Serial: RA-16-0023  
May 4, 2016

SHEARON HARRIS NUCLEAR POWER PLANT, UNIT 1  
DOCKET NO. 50-400 / RENEWED LICENSE NO. NPF-63

H. B. ROBINSON STEAM ELECTRIC PLANT, UNIT NO. 2  
DOCKET NO. 50-261 / RENEWED LICENSE NO. DPR-23

**SUBJECT: SUPPLEMENTAL INFORMATION FOR LICENSE AMENDMENT REQUEST  
REGARDING METHODOLOGY REPORT DPC-NE-1008-P**

**Figure 3-1**  
**CASMO/SIMULATE Code Sequence**

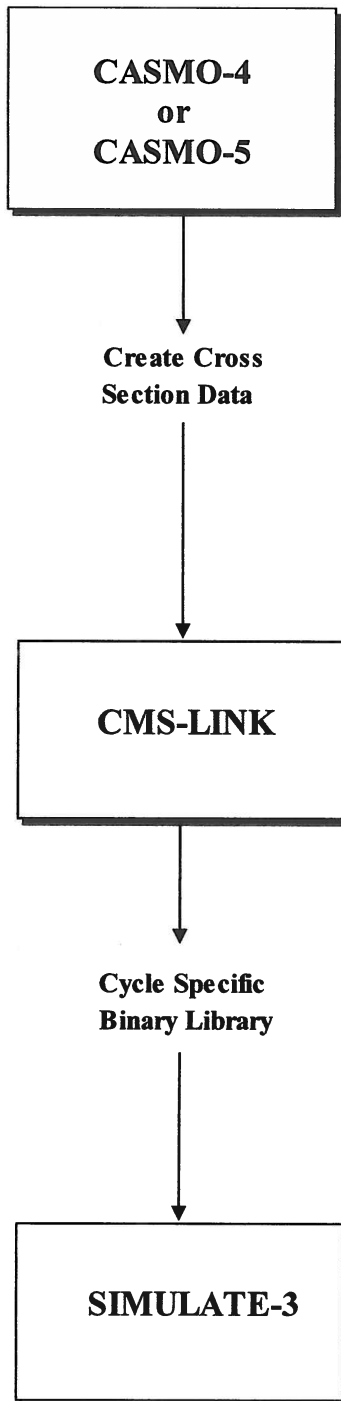
Description of Change: Figure 3-1 is updated to include the CASMO-5/SIMULATE-3 nuclear analysis method.

Instrumented Fuel Assemblies  
McGuire and Catawba

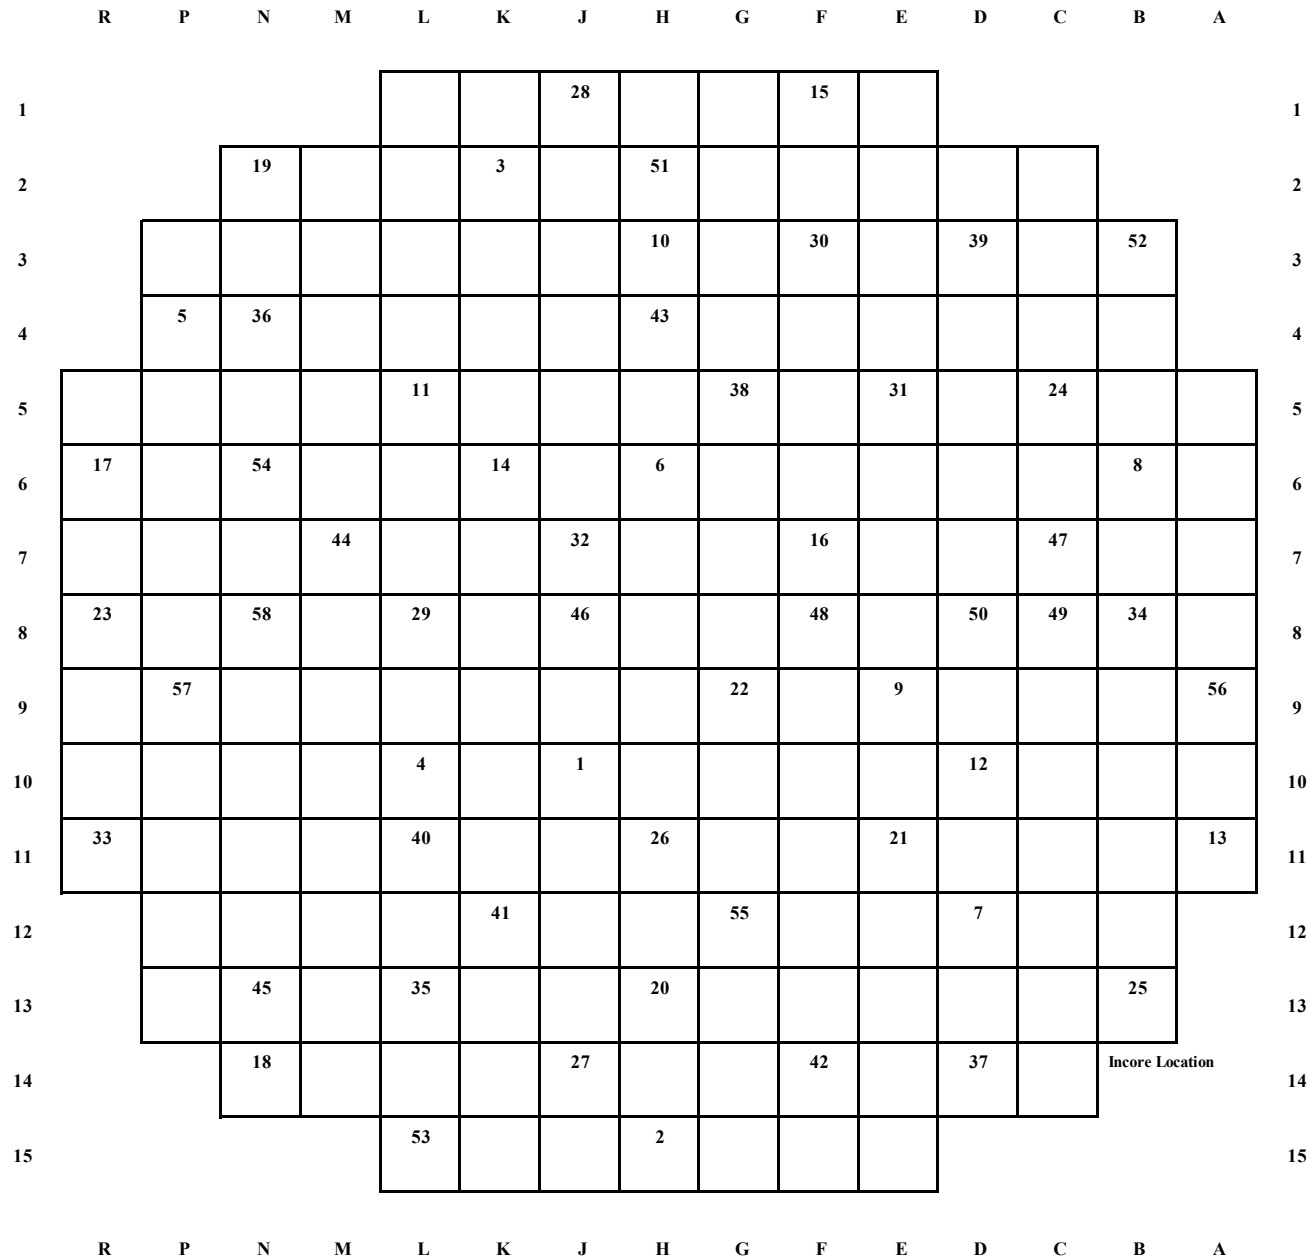
Description of Change: Figure 11-1 is replaced to show incore instrument identifiers.

Instrumented Fuel Assemblies  
Harris

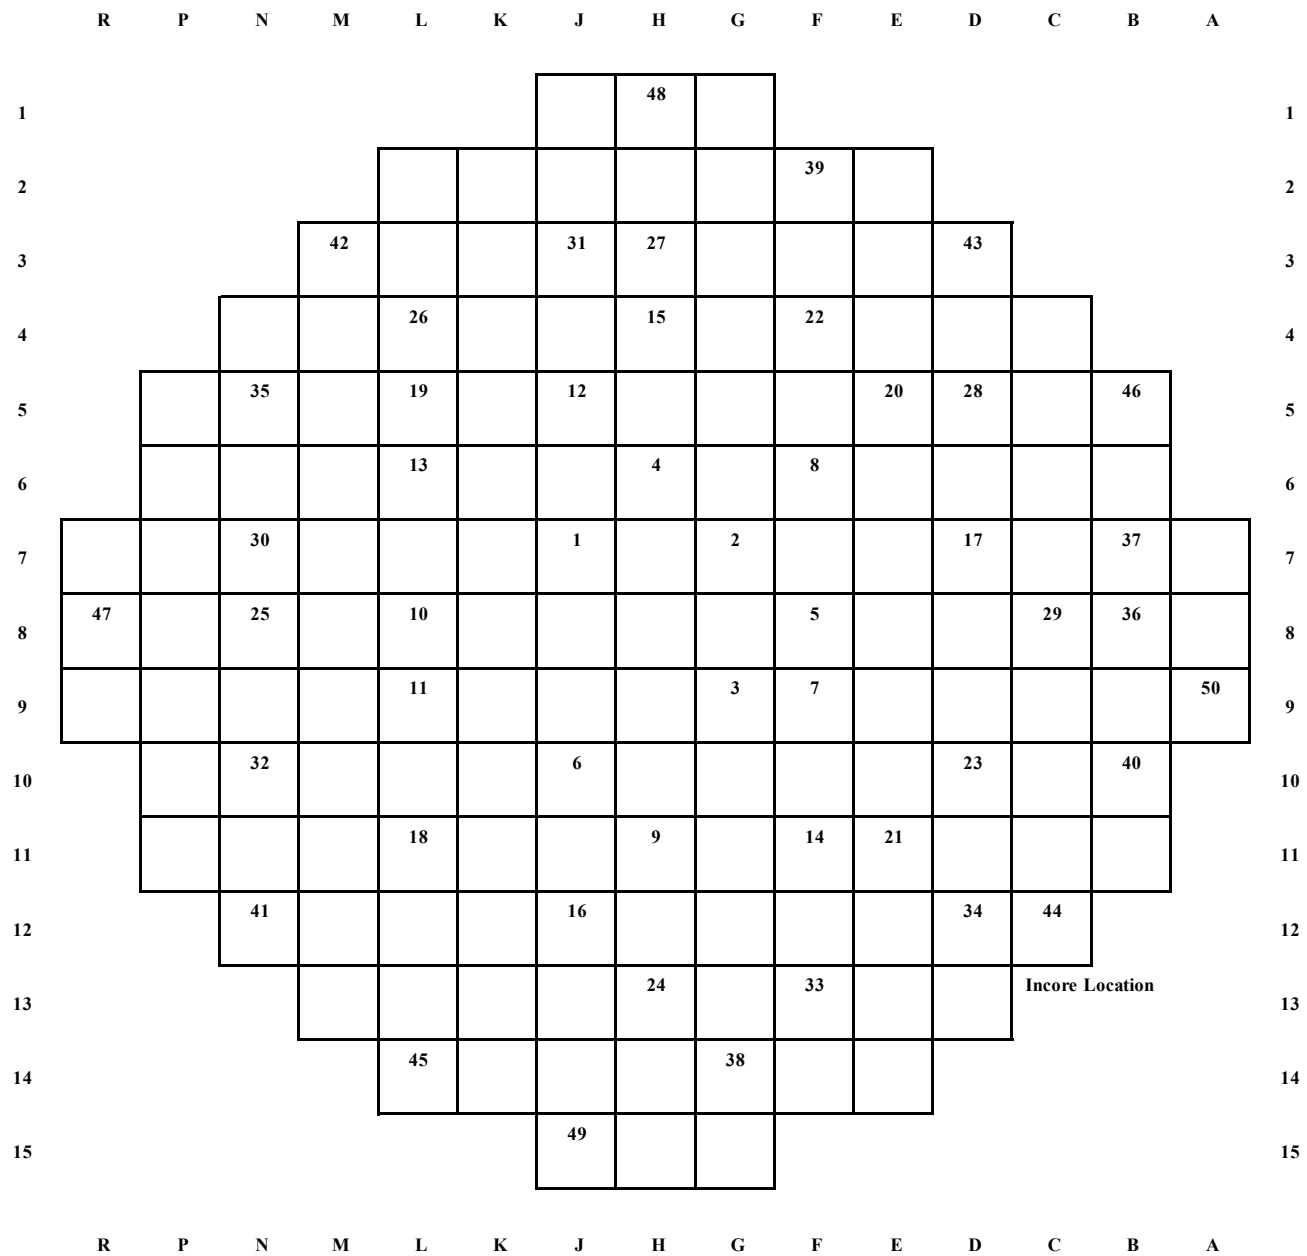
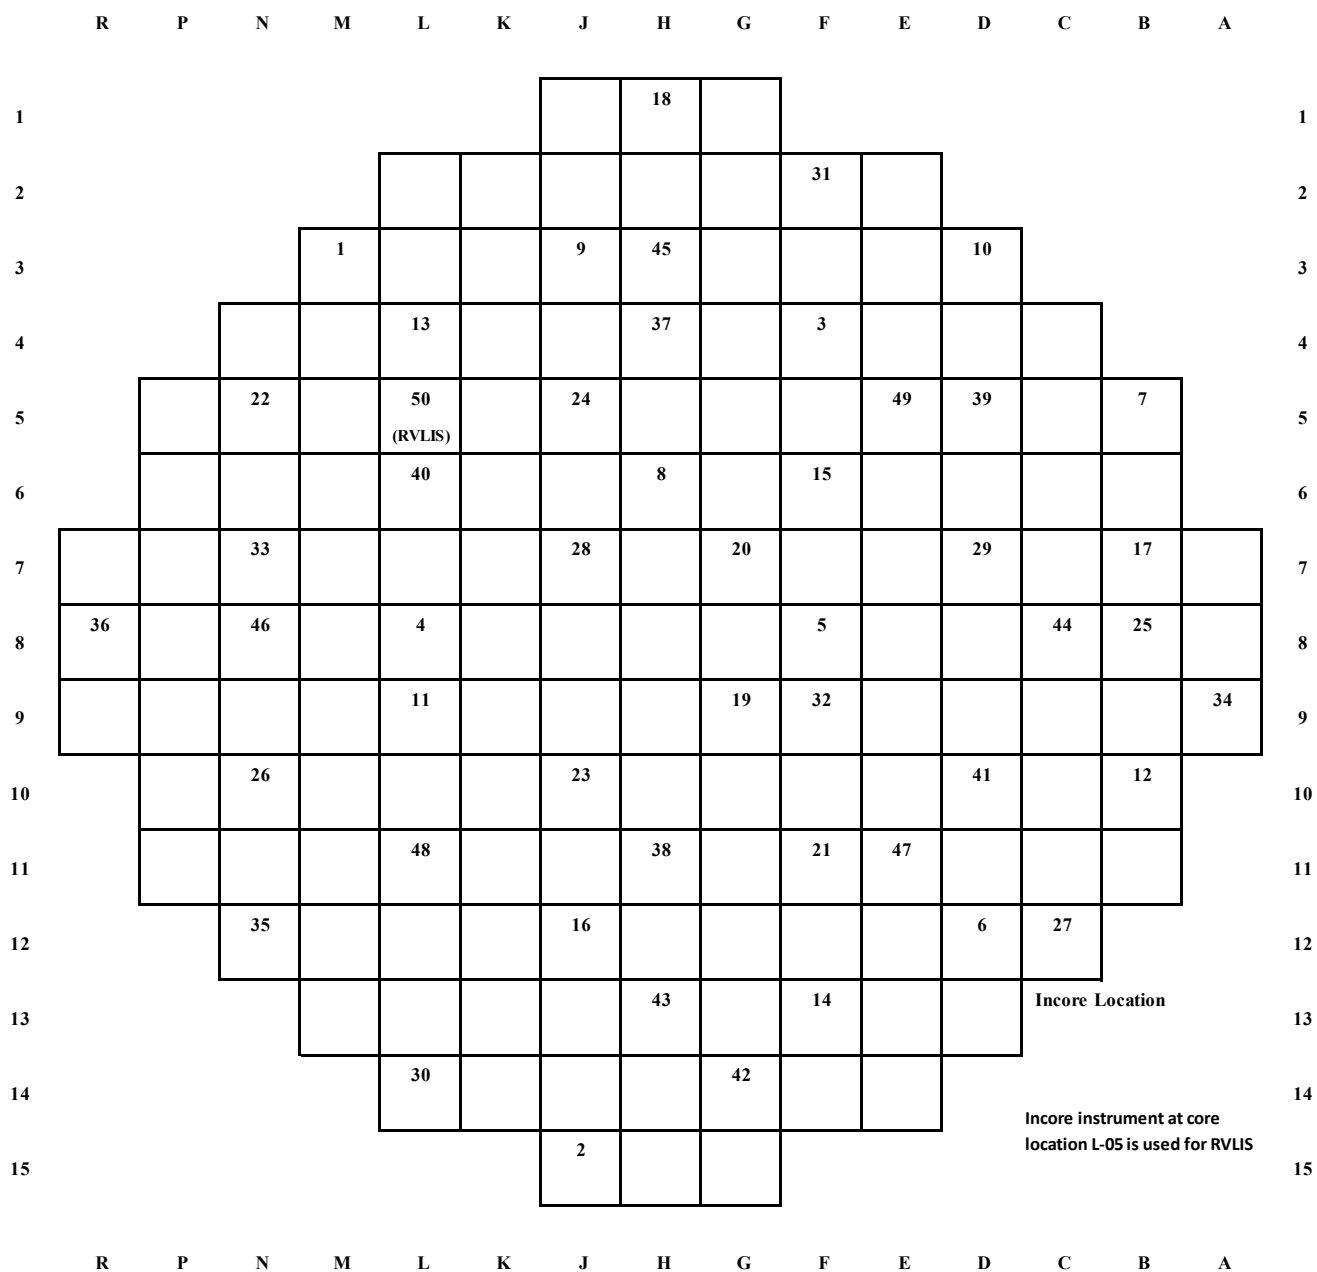
Description of Change: Figures 11-2 and 11-3 were added which show the instrumented core locations for Harris and Robinson, respectively.

Description of Change: Instrumented core locations for the Harris and Robinson reactors are added as new Figures 11-2 and 11-3.

### Change 6-12: Figures 9 and 12

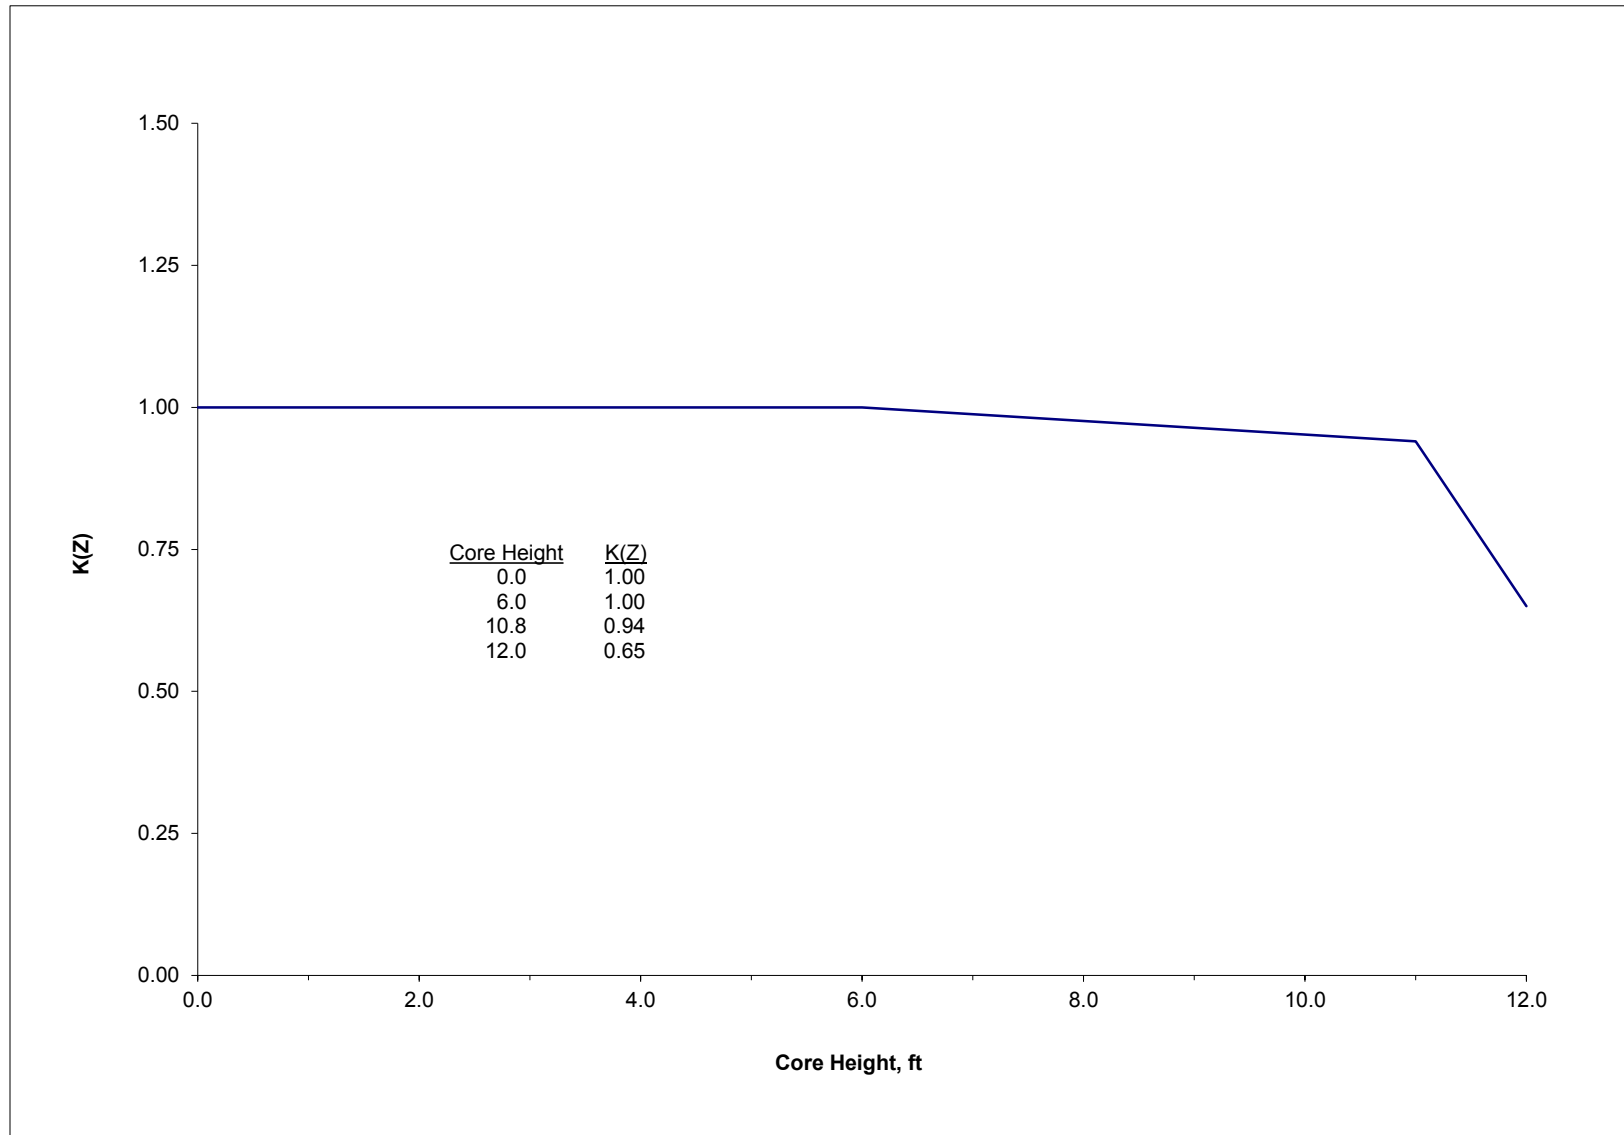
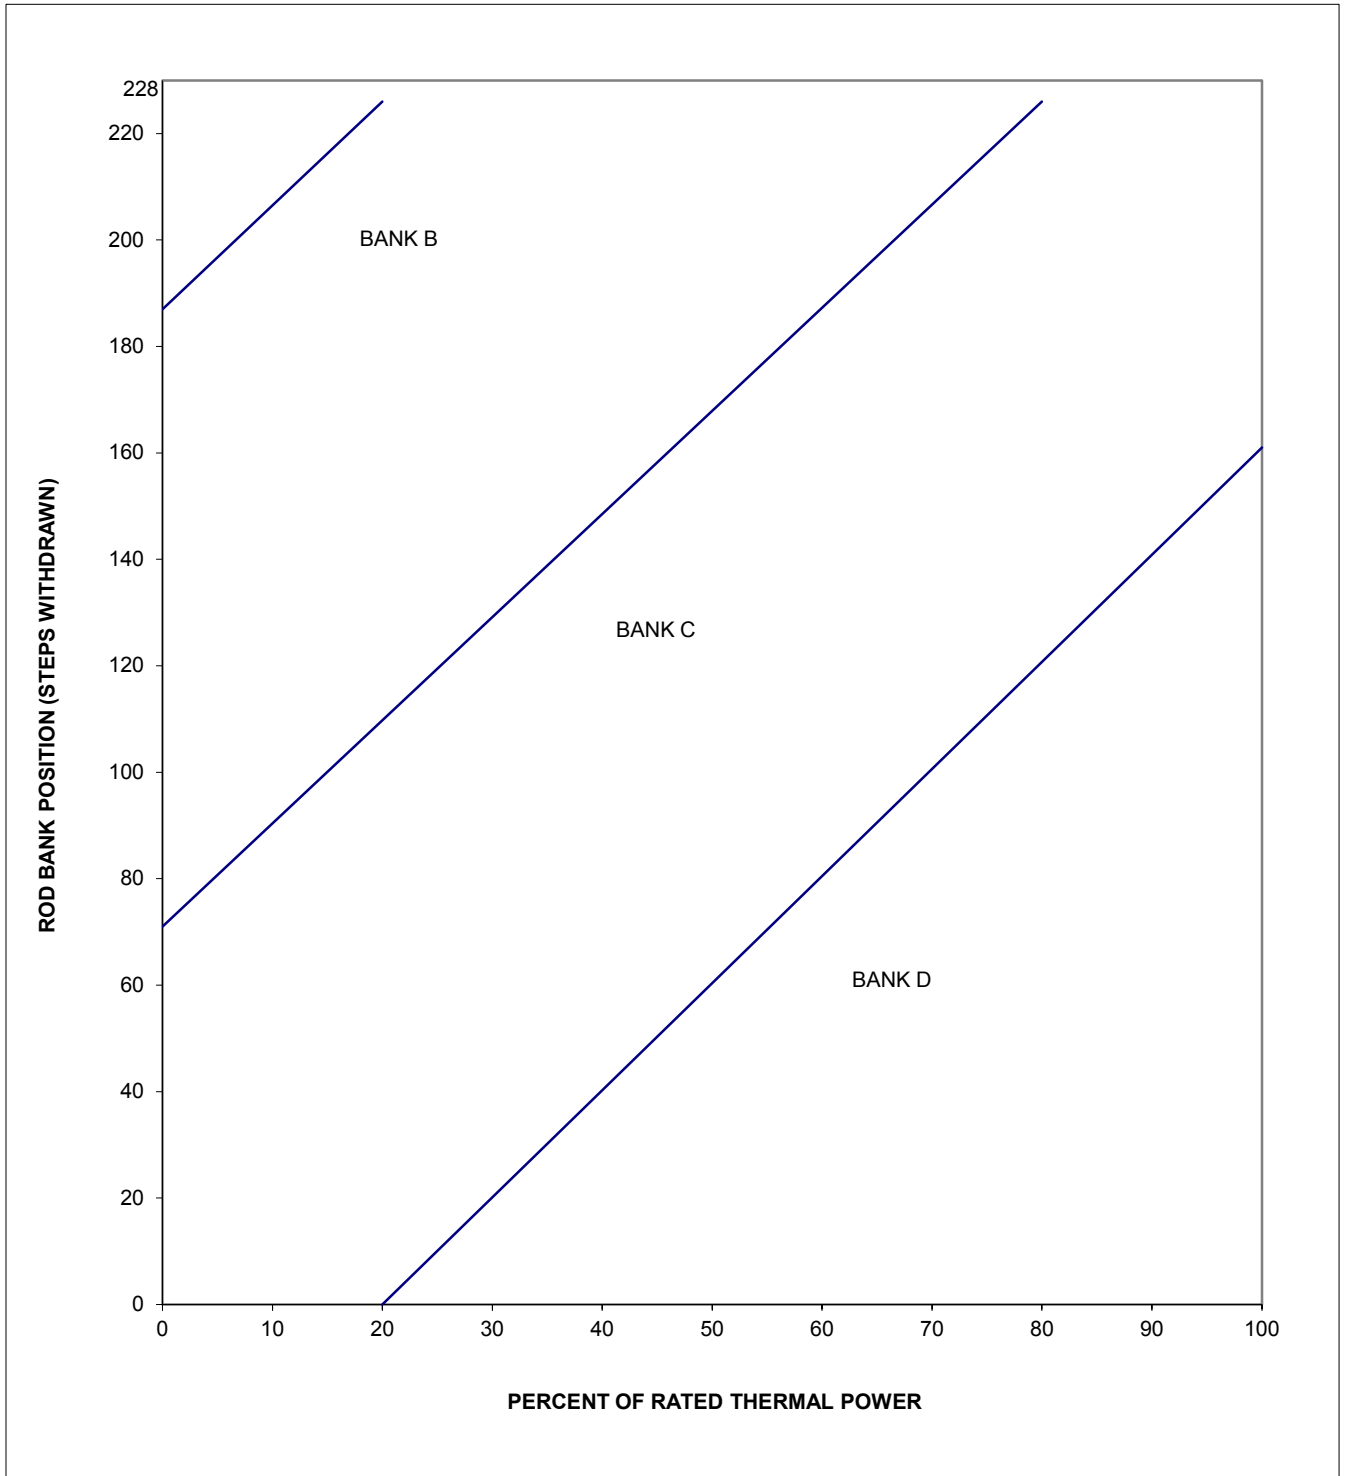
Description of Change: The titles of Figures 9 and 12 are changed to denote the K(Z) and rod insertion limits specified are sample limits.
